**APPENDIX E:**  
**AGENCY COMMENT ON RTS AND AMENDED DA**

**Jupiter Wind Farm Response to Submissions (RTS) and Preferred Project Report (PPR) -  
OEH review**

**Jupiter Wind Farm (SSD 6277)  
Response to Submissions & Preferred Project Report (RTS-PPR)**

**Re: Jupiter Wind Farm Project – SSD 6277  
Response to Submissions and Amended Development Application**

**Jupiter Wind Farm: Northern Precinct - North Cluster: Count of Uninvolved Dwellings <= 3km**

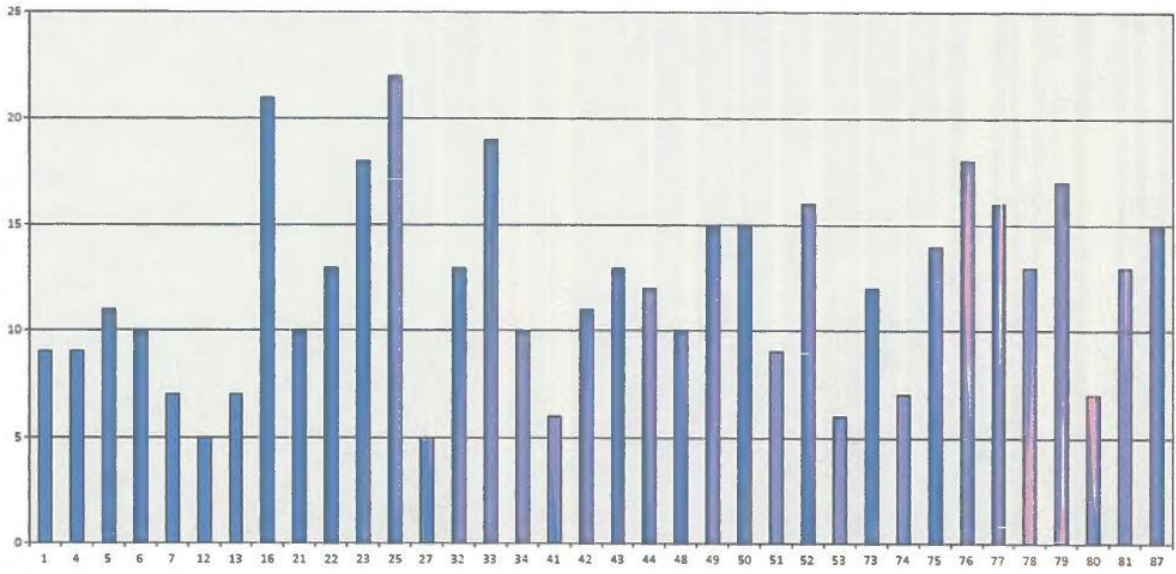
1. Unacceptable visual impact – Although the number of wind towers has been amended downwards to 57 the visual impact on residences in the region is still significant. Please find attached a graph showing the impacts these towers have on the dwellings in the region within the Goulburn Mulwaree area. If you look at the graph you will see for example that tower 25 can be seen by 22 houses.
